# intel® Technical Advisory

TA-569-1

## Main Power connector latch on SE7500CW2 not long enough for all power supplies

**Figure 1:** Pictures of the current 24-pin and 8-pin connectors on the SE7500CW2 board.

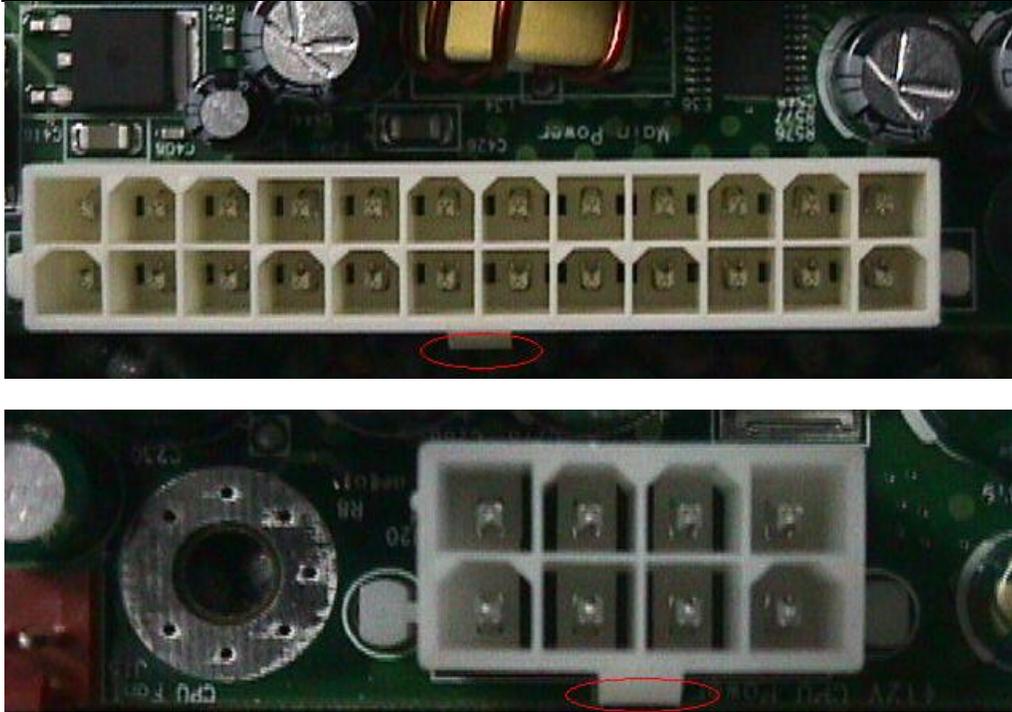
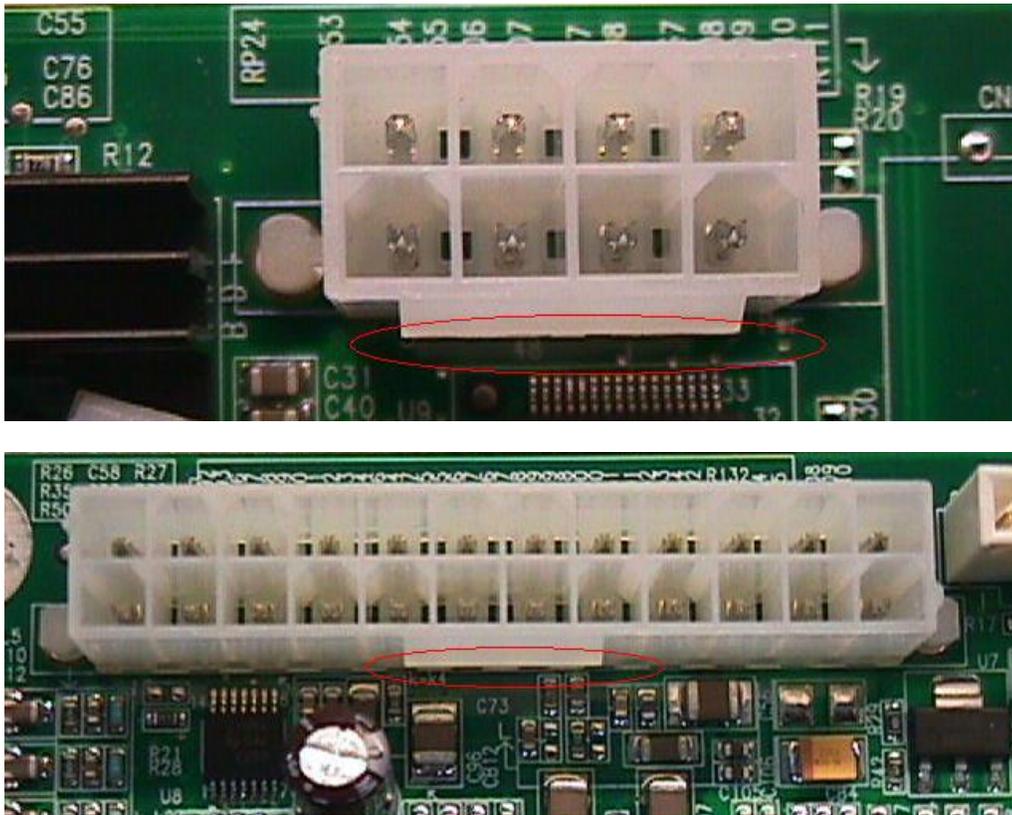
The SE7500CW2 server board is currently shipping with an incorrect version of main 24-pin SSI power supply connector and 8-pin +12V connector on the board. The version that is on these boards has a shorter retention latch and may not allow ATX style power supplies to lock securely into place when installed. Since ATX power supplies use only a 20-pin power connector, the latch for this connector is off center and may not engage when inserted into a 24-pin SSI power connector found on most Intel server boards. This could cause the power supply connector to become unseated when the system is shipped or when it is handled extensively.

The shortened latch is in the wrong location for a 20-pin ATX power plug. On a power supply connector, the power plug latch is usually centered on the connector. Intel uses a 24-pin main power connector with the latch centered between pins 12 and 13. If a customer were to plug a 20-pin ATX power supply into this connector, the latch on that connector is centered between pins 10 and 11. This is off center enough that it won't engage the latch on the 24-pin connector. To resolve this, Intel uses a 24-pin power connector with an extended latch that would accommodate either a 24-pin or 20-pin power plug. This connector is not on the current boards mentioned above.

**Figure 2:** Sample of what the power-supply connectors will look like on the A87967-506 and above baseboards. Notice the latch is much wider than what is currently on the SE7500CW2 server board.

Intel will be putting the correct power supply connector on boards starting on the -506 board PBA revision. This change will likely take place in October, 2002. Please refer to this Technical Advisory for any updates to this implementation date.
